# UNITED STATES PATENT AND TRADEMARK OFFICE

10/748,059

<b>Office Action Summary</b>	<b>Application No.</b> 10/748,059	<b>Applicant(s)</b> TENHUISEN ET AL.	
	<b>Examiner</b> DIANNE DORNBUSCH	<b>Art Unit</b> 3773

## DETAILED ACTION

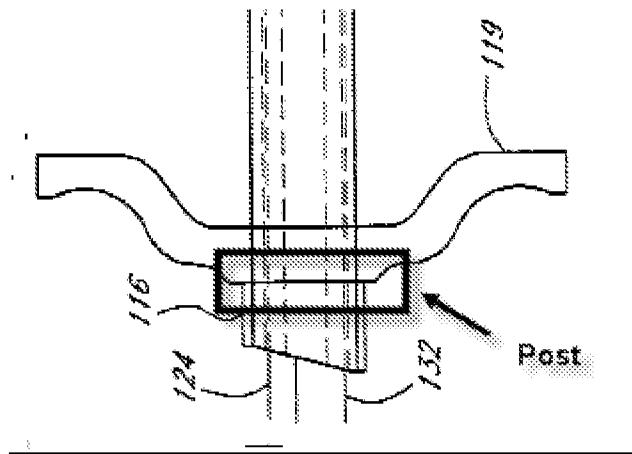
Claim 9: Mikus discloses all the claimed limitations discussed above (see rejection of claims 1-4 and 6-8) including that said grip portion (119) has a hollow post (see figure below) extending from said hub (Fig. 13), said post having a relief slot (the distal opening of the post) on a distal end thereof (see figure below), said relief slot positioned on said post to align with said tab when said tab is in the deployed position (Fig. 13-14), said tab capturing the at least one protrusion of the stent between said tab and said relief slot when said apparatus compresses the at least one protrusion (Fig. 13).

Note that the relief slot of claim 1 is on said hub and not and said post. The post is not claimed in claim 1 therefore a different release slot in the same reference was used.
